Title: ZX Interface 1 New Layout SMD PLCC

Size: A4	Date: 2026−10−28	**Rev: 2.0**
KiCad E.D.A. 10.0.6		Id: 3/3

Sheet: /Microdrive IO/
File: Microdrive_IO.kicad_sch

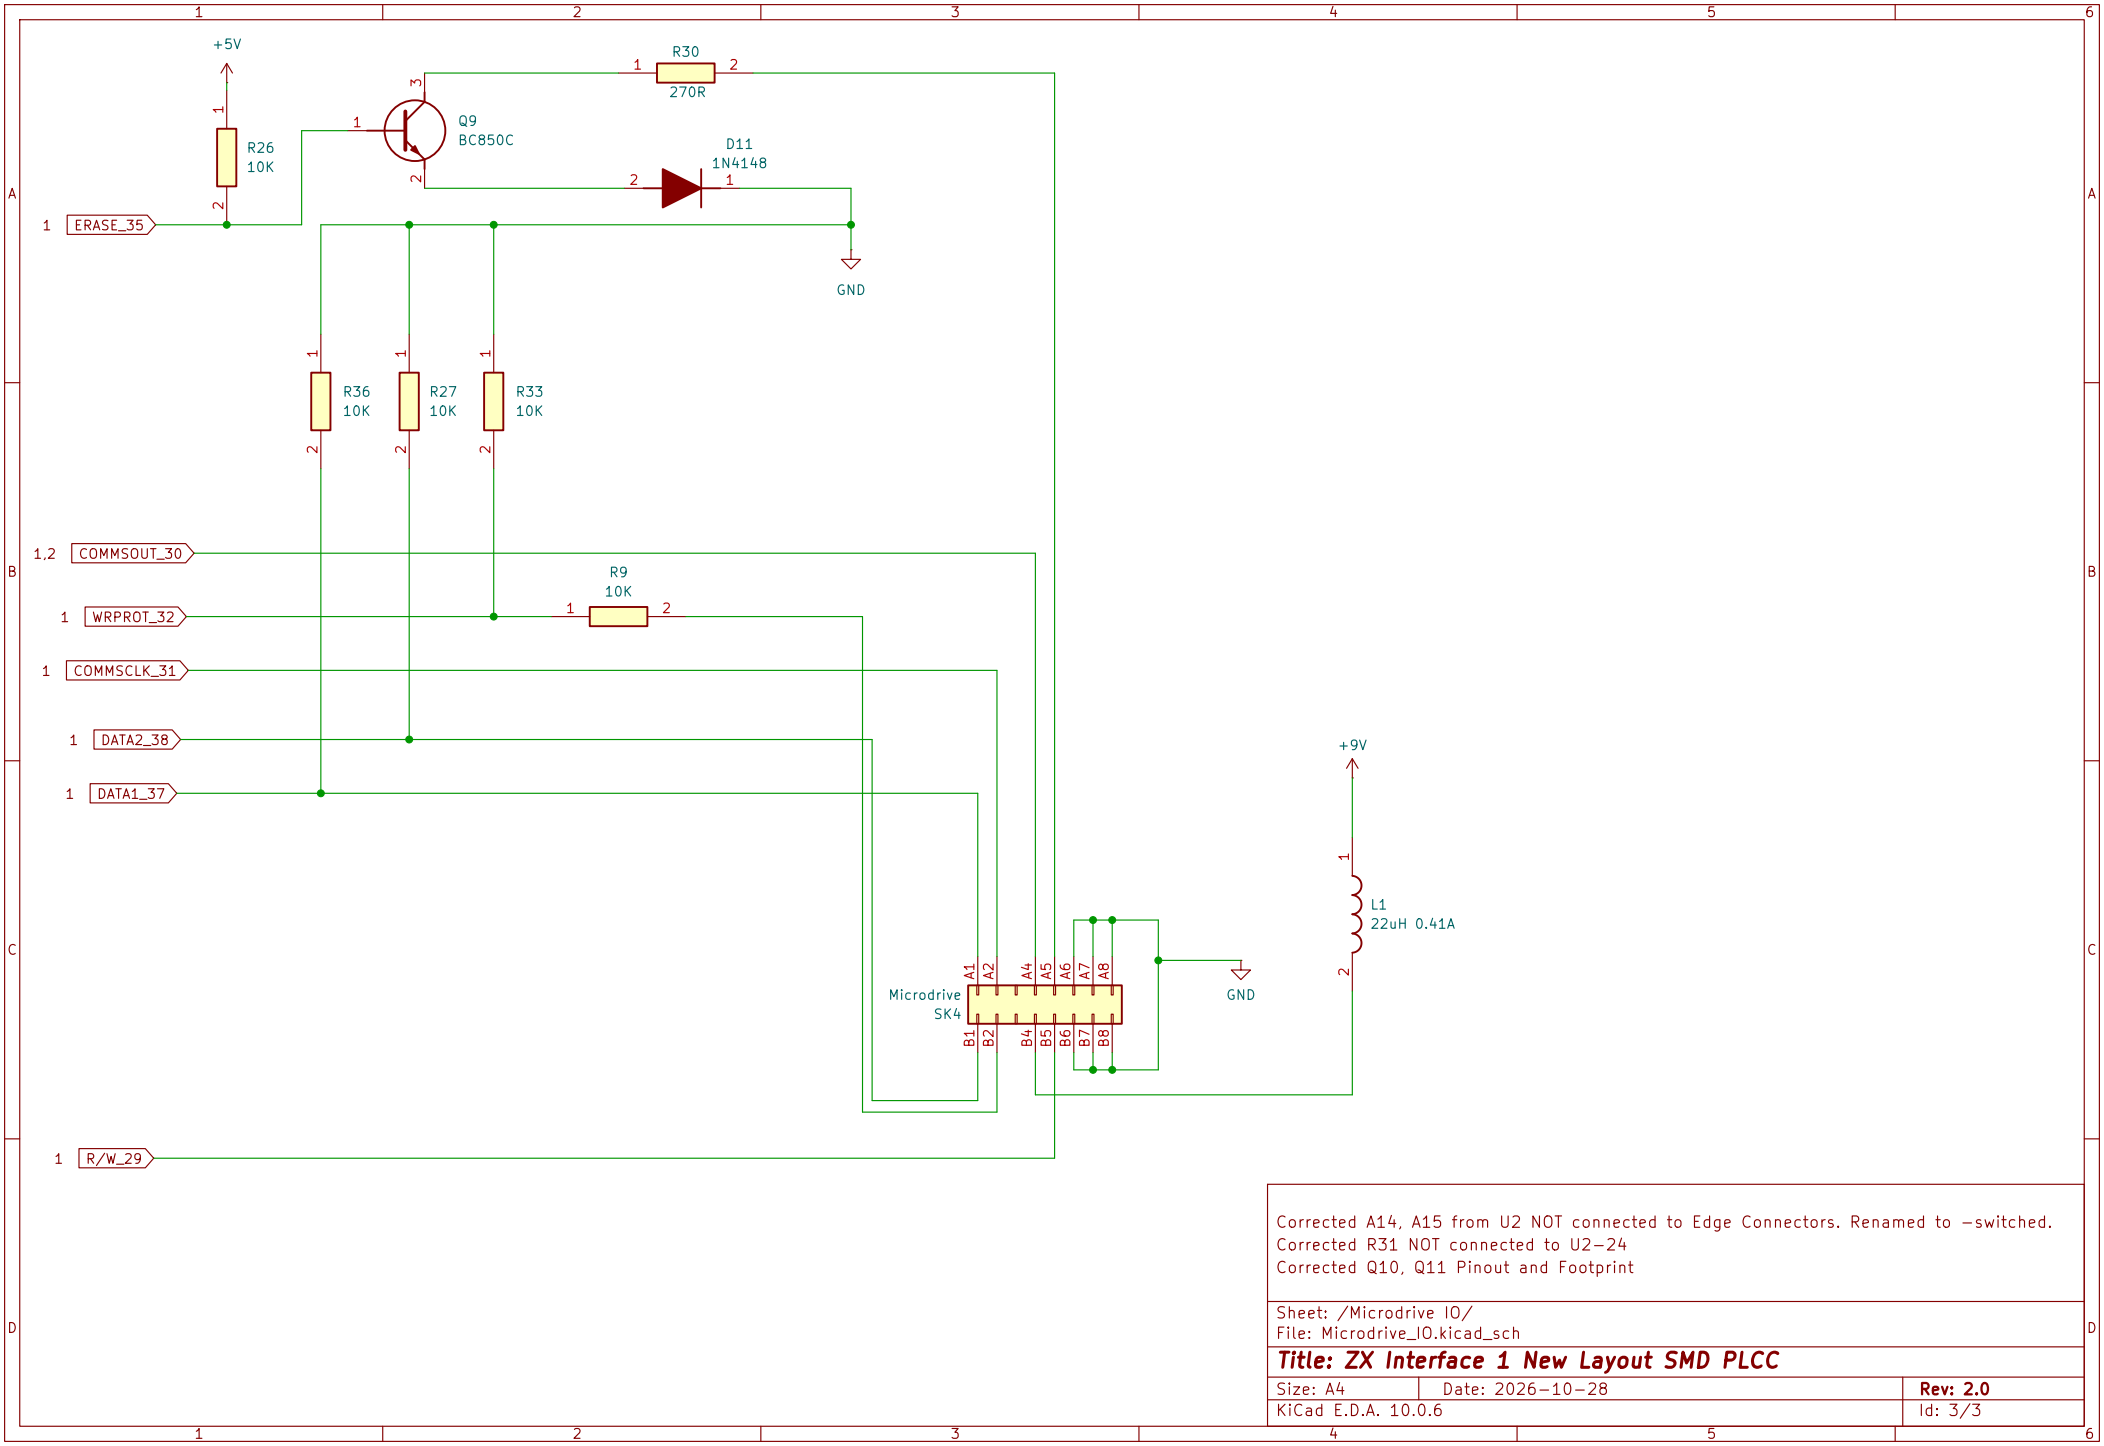
Corrected A14, A15 from U2 NOT connected to Edge Connectors. Renamed to −switched.
Corrected R31 NOT connected to U2−24
Corrected Q10, Q11 Pinout and Footprint
